Report to Planning Committee 10 August 2023

Report Summary			
Application Number	22/01298/FUL		
Proposal	Proposed retail unit with parking and amended site entrances		
Location	Tesco Express, Kirklington Road, Rainworth, NG21 0AE		
Applicant	Mr K Nijjar	Agent	Alan McGowan Architects - Mr Alan McGowan
Registered	30 June 2022	Target Date	25 August 2022
		Extension of Time	18 August 2023
Web link	22/01298/FUL Proposed retail unit with parking and amended site entrances Tesco Express Kirklington Road Rainworth Nottinghamshire NG21 0AE		
Recommendation	That planning permission is APPROVED subject to the conditions outlined at the end of this report

Kirklington Road pedestrian central refuge

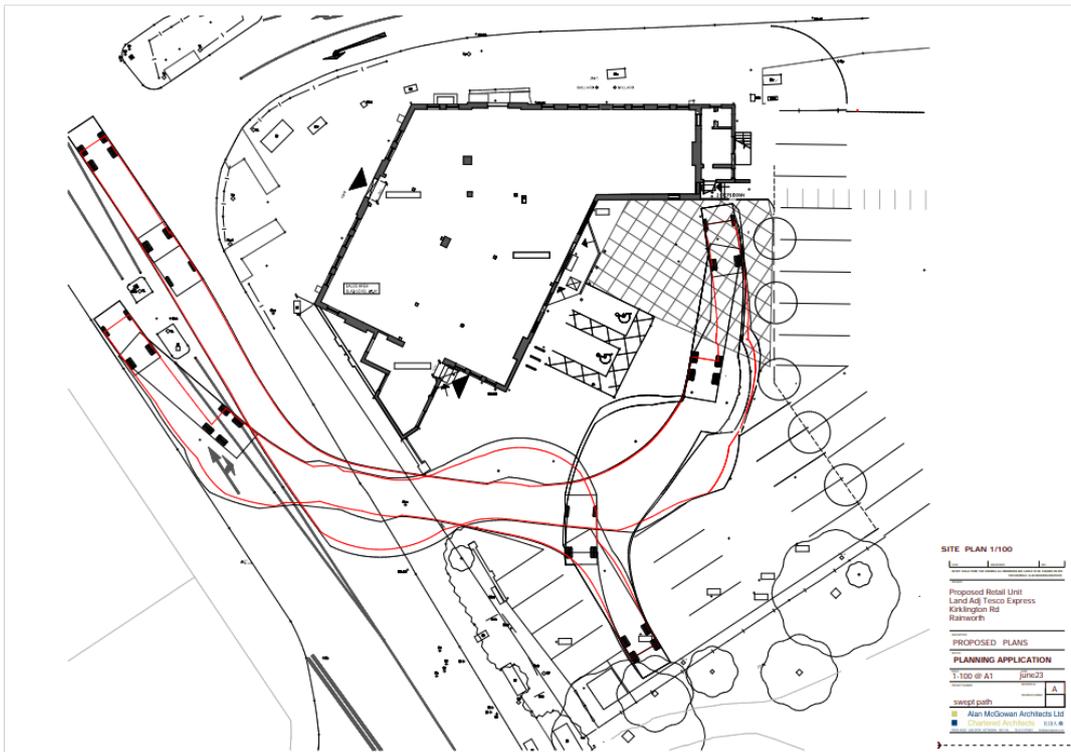
Highways - Pedestrian central refuge on Kirklington Road near the access is now shown on all the newly submitted plans. This refuge is to remain as existing and, for clarification, it is not proposed to be removed.

Despite being consulted on revisions, Rainworth Parish Council still believe the pedestrian central refuge will be removed to facilitate access, however, this is not the case, and the scheme has been amended accordingly to clarify. Before the scheme was amended to enable the existing and proposed retail units to share the Southwell Road East access for deliveries, the Highway Authority was concerned that delivery lorries would cut across part of the pedestrian central refuge when turning right out of the Kirklington Road access (see comments regarding swept path analysis below). To confirm, it was never proposed to remove this element of the highway, which is out of the applicant's control.

Swept Path Analysis for Delivery Vehicles

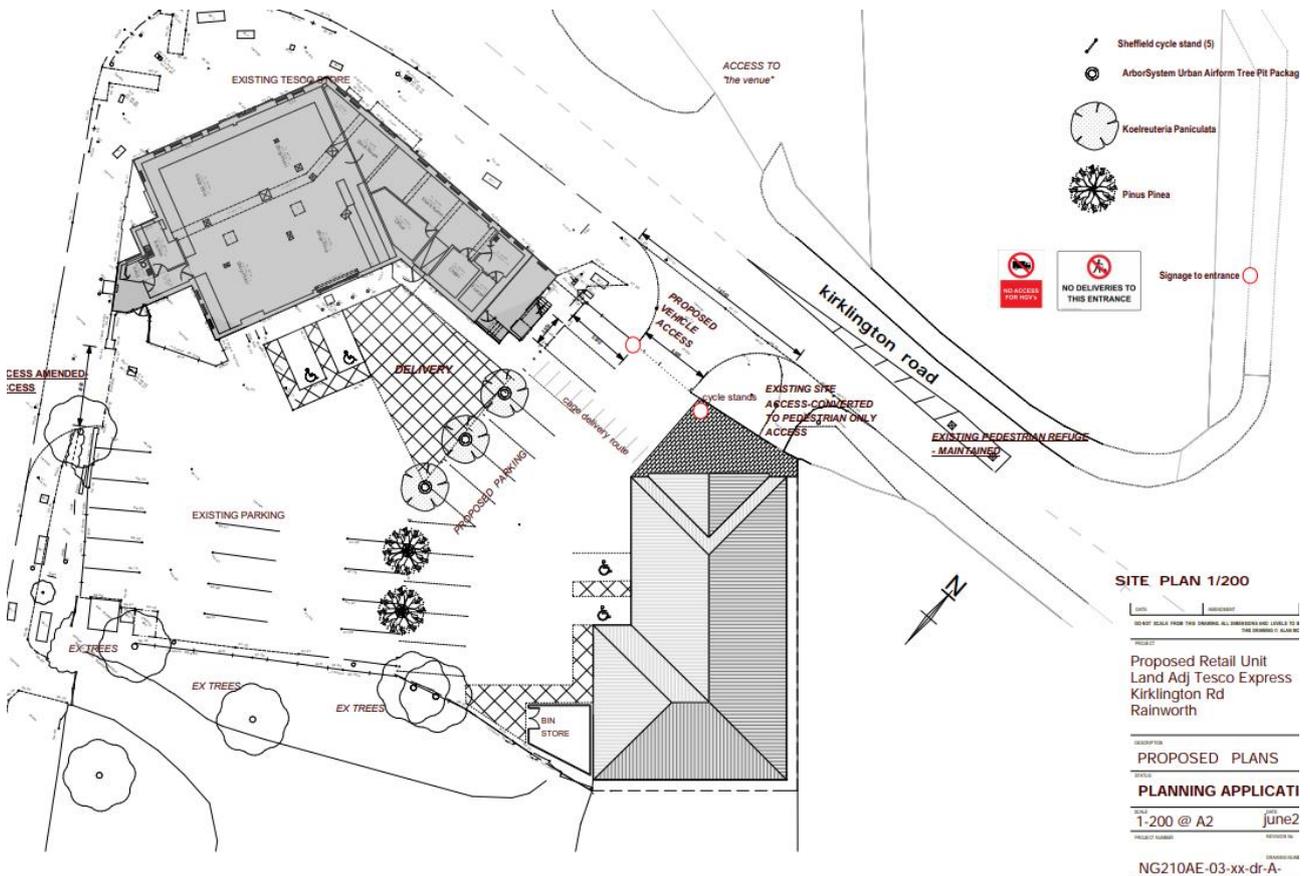
Highways - As the previously submitted swept path analysis revealed the lack of space for a delivery vehicle to manoeuvre within the site to enter and exit the highway in forward gear, the applicant has put forward a proposal to use an existing access and delivery bay for current Tesco Extra store on the adjacent site. The red-line location plan was amended in order to accommodate this proposal, and this seems a reasonable solution for the size of the proposed unit. Please note that signs should be erected at the access to the new store prohibiting HGVs to enter the site via the access off Kirklington Road once the store becomes operational. All deliveries must be carried out from the delivery bay adjacent to current Tesco Extra. A delivery method statement should be provided by the applicant, which should secure this arrangement. This can be conditioned.

The 002 Swept Path Analysis *received 17 April 2023* illustrated there was sufficient space for delivery vehicles to enter and leave the site via the widened Southwell Road East access but did not illustrate how delivery vehicles would manoeuvre within the site. Ahead of June Planning Committee the applicant, via their agent, confirmed that tracking would mirror that which enabled the Tesco store to be approved and provided an updated swept path drawing to reflect this. However, this drawing illustrated potential conflicts between the lorry turning area and proposed tree planting. The scheme was therefore withdrawn from the June Planning Committee Agenda to allow the applicant time to address this conflict.

Revised Swept Path Analysis *received 20 July 2023* illustrates there is sufficient space for delivery vehicles to enter and leave the site via the widened Southwell Road East access in a forward gear without interfering with proposed tree planting (see image below).

Highways has confirmed this is acceptable. The Council's Tree Officer has also confirmed this is acceptable, subject to a condition to secure lorry proof tree guards, i.e., metal guards that rest on the ground and wrap around tree trunks to protect trees. Such guards are widely used in public areas. Condition 09 requires full details of all proposed tree planting to be submitted to and approved in writing by the LPA prior to first occupation of the retail unit including details of such tree guards.
